PRODUCT CHANGE NOTICE

PCN # USB1080-002

Drawing Revision Letter: D

USB1080-30-B

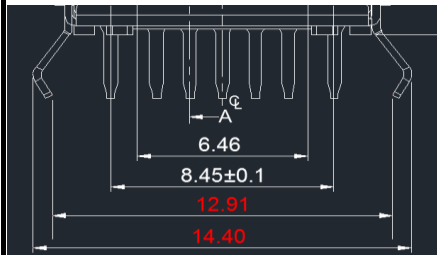
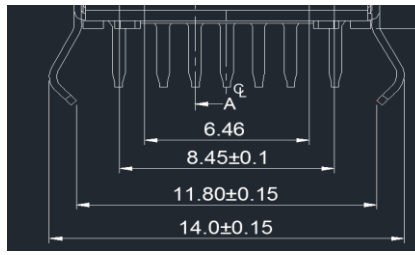
Correction to drawing:

Shell stake dimensions amended from 12.91/14.40mm to 11.80/14.0mm

No change to PCB layout required.

To correct drawing. No change to physical parts.
